Product Change Notification

Product Group: OPT/Friday September 4, 2026/PCN-OPT-1503-2026-REV-0

Qualification of new chipset and BOM for 350 V and 400 V solid state relays

QUALIFICATION OF NEW CHIPSET AND BOM FOR 350V and 400V DIP6, DIP4 AND DIP8 SOLID STATE RELAY

Post- PCN characteristics

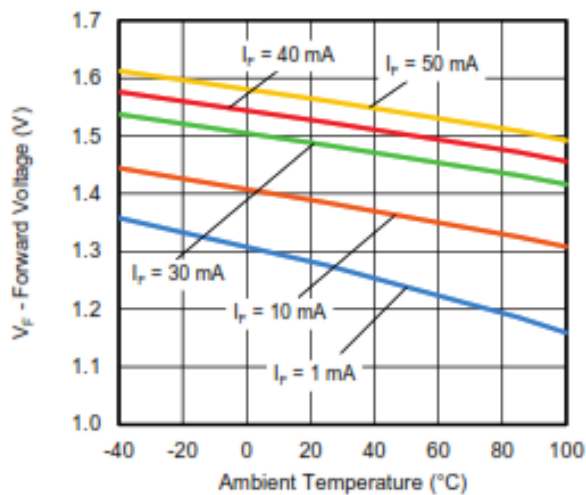
1. Comparison of electrical characteristics

ELECTRICAL CHARACTERISTICS ($T_{AMB} = 25^{\circ}\text{C}$, unless otherwise specified)						
PARAMETER	TEST CONDITION	SYMBOL	MIN.	TYP.	MAX.	UNIT
OUTPUT						
On-resistance (AC/DC configuration)	$I_F = 5\text{ mA}$, $I_L = 50\text{ mA}$	R_{ON}	-	18	27	Ω
Off-state leakage current	$I_F = 0\text{ mA}$, $V_L = \pm 100\text{ V}$	I_O	-	<0.25	200	nA
	$I_F = 0\text{ mA}$, $V_L = \pm 300\text{ V}$	I_O	-	0.5	1000	nA
Output capacitance (AC/DC configuration)	$I_F = 0\text{ mA}$, $V_L = 1\text{ V}$, 1 MHz	C_O	-	44	-	pF
	$I_F = 0\text{ mA}$, $V_L = \pm 50\text{ V}$, 1 MHz	C_O	-	6	-	pF
TRANSFER						
Capacitance (input to output)	$V_{ISO} = 1\text{ V}$	C_{IO}	-	1.72	-	pF

b. Forward current vs forward voltage

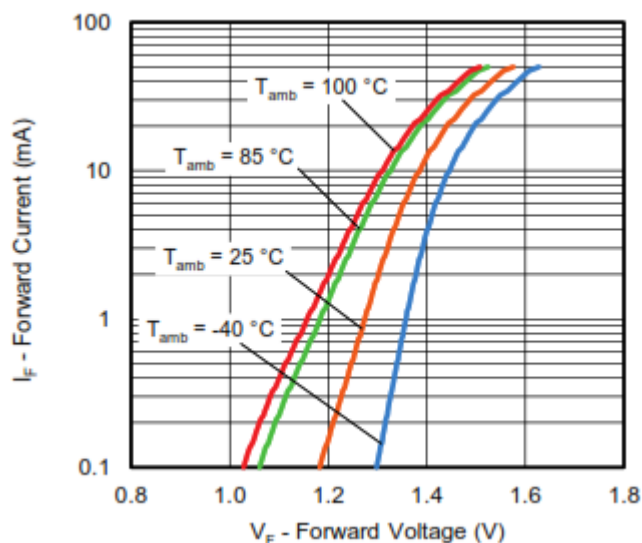
2. Typical curves: Below typical curves have been updated in the respective product datasheets.

(For parts with $T_{amb} \text{ max} = 85^{\circ}\text{C}$, the $T_{amb} = 100^{\circ}\text{C}$ curve is not applicable)
